Sony APR-5000 Reel Motor Drive Board

RMD BOARD
 BOARD NO. 1-619-160-11 & HIGHER
 APR-5002/5003

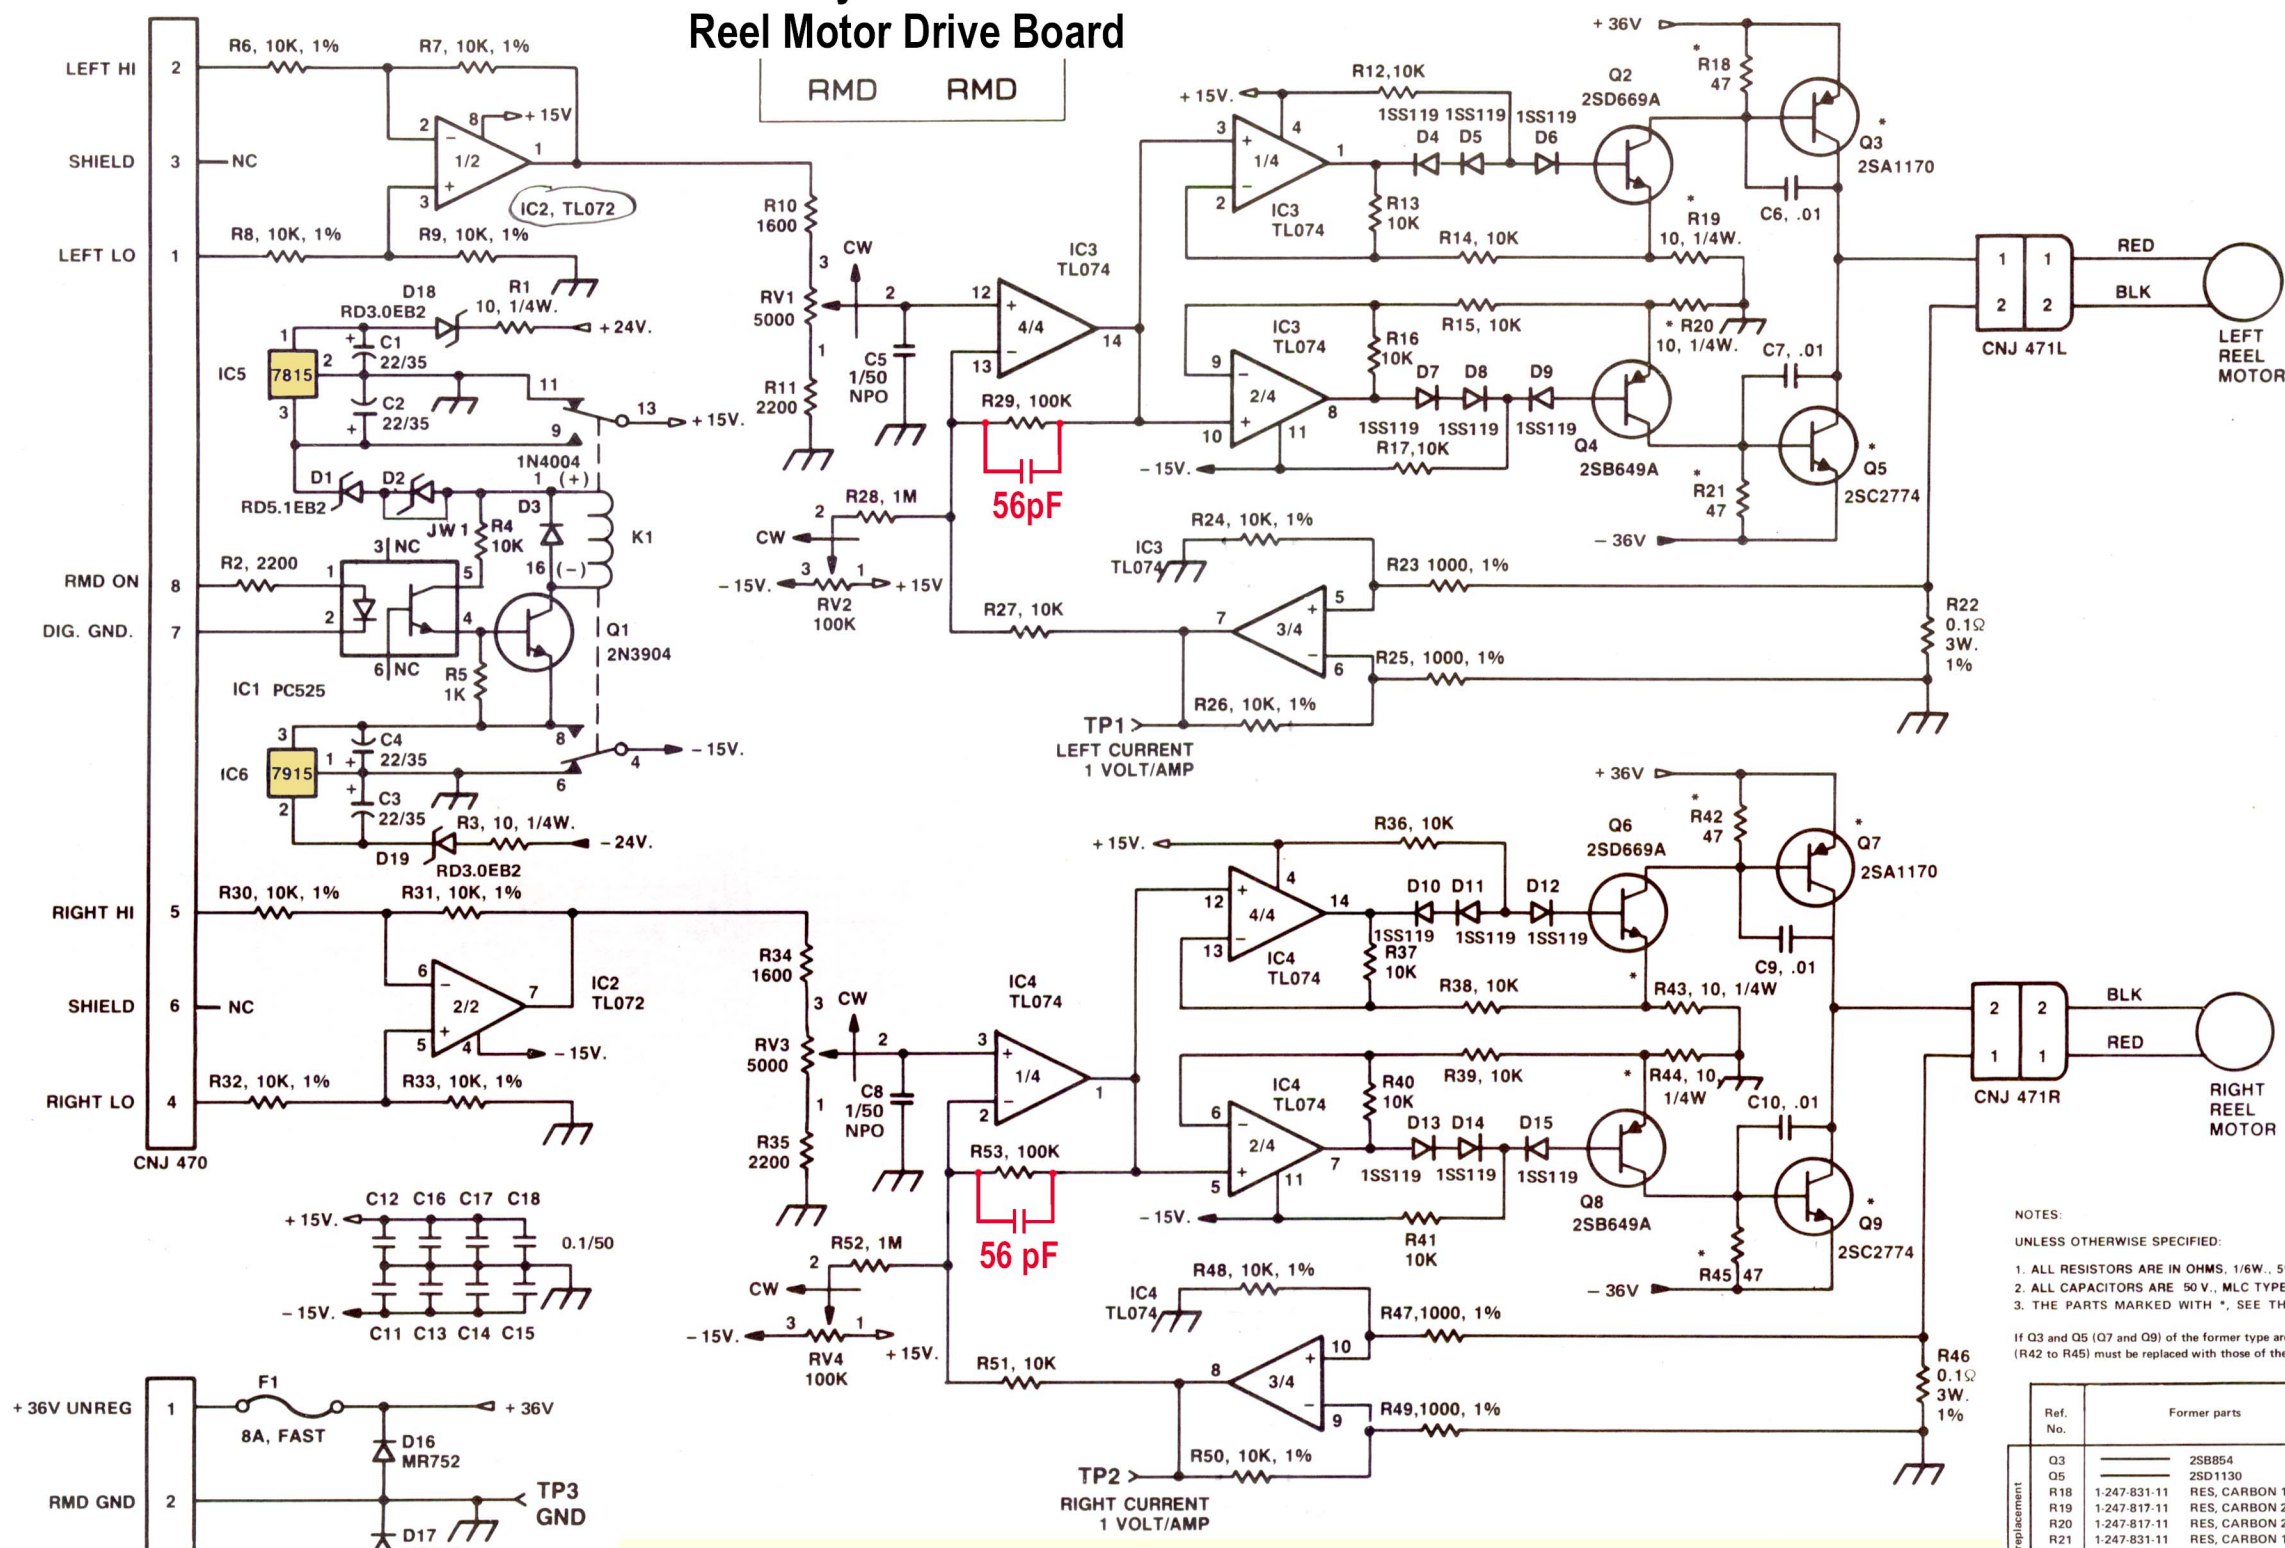
NOTES:
 UNLESS OTHERWISE SPECIFIED:
 1. ALL RESISTORS ARE IN OHMS, 1/6W., 5%.
 2. ALL CAPACITORS ARE 50 V., MLC TYPE.
 3. THE PARTS MARKED WITH *, SEE THE FOLLOWING TABLE.
 If Q3 and Q5 (Q7 and Q9) of the former type are replaced with those of the new type, R18 to R21 (R42 to R45) must be replaced with those of the new type at the same time.

Ref. No.	Former parts	New parts
Q3	2SB854	8-729-300-24 2SA1170
Q5	2SD1130	8-729-300-18 2SC2774
R18	1-247-831-11 RES, CARBON 1K	1-249-401-11 RES, CARBON 47
R19	1-247-817-11 RES, CARBON 270	1-247-688-11 RES, CARBON 10
R20	1-247-817-11 RES, CARBON 270	1-247-688-11 RES, CARBON 10
R21	1-247-831-11 RES, CARBON 1K	1-249-401-11 RES, CARBON 47
Q7	2SB854	8-729-300-24 2SA1170
Q9	2SD1130	8-729-300-18 2SC2774
R42	1-247-831-11 RES, CARBON 1K	1-249-401-11 RES, CARBON 47
R43	1-247-817-11 RES, CARBON 270	1-247-688-11 RES, CARBON 10
R44	1-247-817-11 RES, CARBON 270	1-247-688-11 RES, CARBON 10
R45	1-247-831-11 RES, CARBON 1K	1-249-401-11 RES, CARBON 47

- 1.) confirm that transistors are good and reflow solder if necessary
- 2.) add 56pF caps in parallel with R29 and R53. If improved but not fixed, experiment.
- 3.) replace c1, c2, c3, c4 around 7815 / 7815
- 3.) Replace c11, c12, c13, c14, c15, c16, c17, c18
- 4.) note caps around Q3, Q5, Q7, Q9. These are supposed to reduce gain at high frequencies, but are not very effective
